# AEBS-HDV-07 industry prep

AEBS-HDV-07

October 26-28, 2021

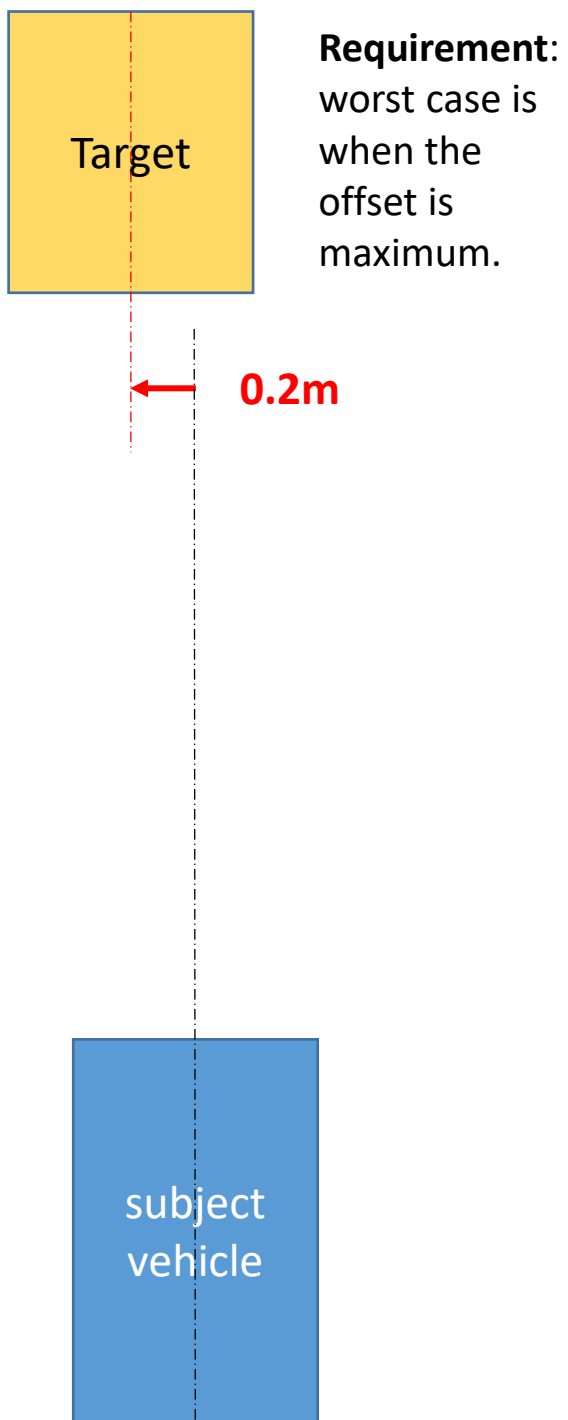
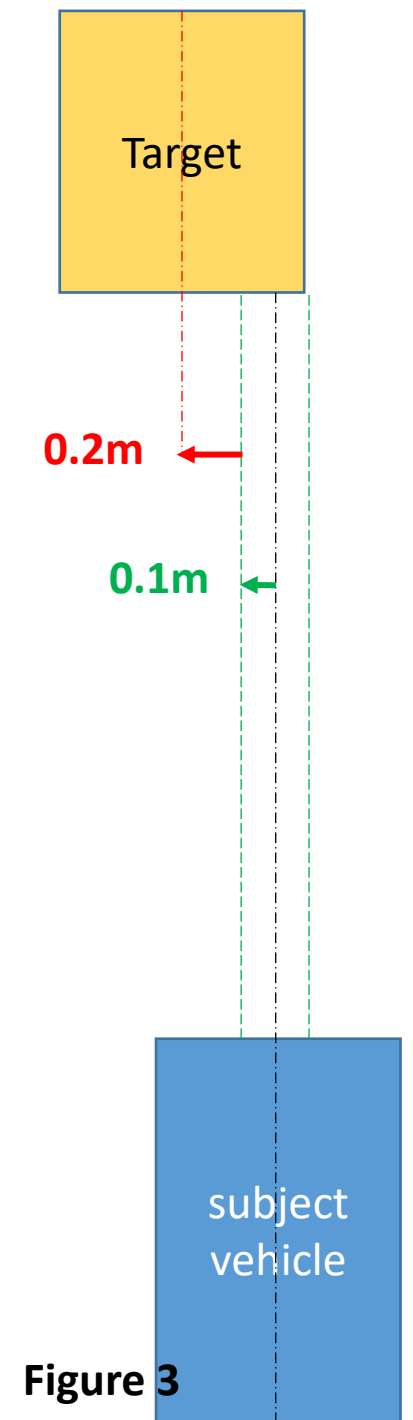
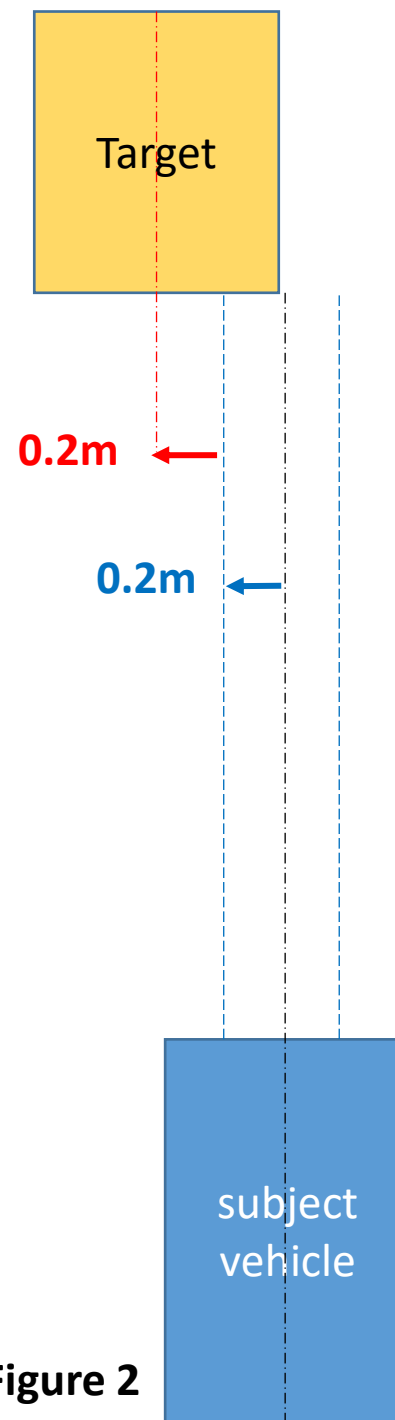
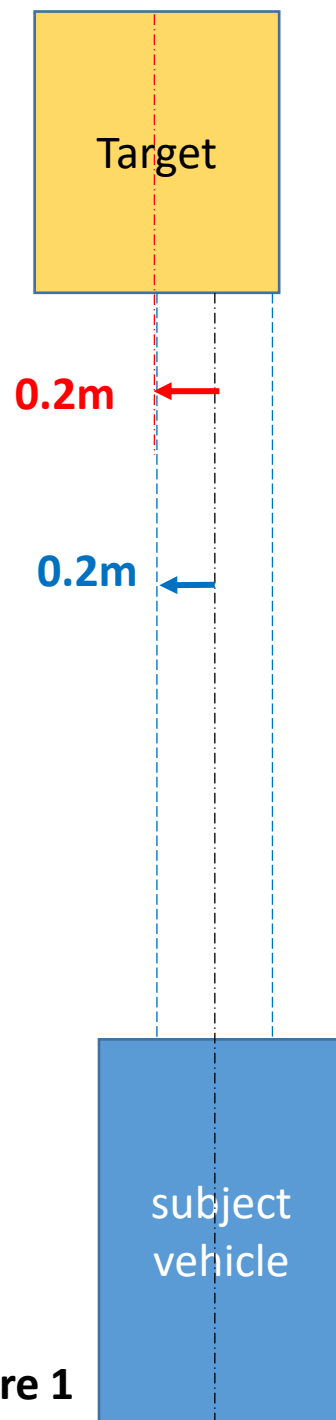
*During the test,  
the vehicle shall  
stay within a  $\pm$   
0.1m corridor*

**Test:**  
during the test, the vehicle has to remain in a +/- 0.2m corridor.

**Question 1:**  
Should the corridor be placed like on figure 1 or 2 ?

With figure 2, the actual requirement is increased by the test tolerances...

**Question 2:**  
If the actual tolerance of the test equipment is 0.1m (and not 0.2m), would figure 3 then be the right way?
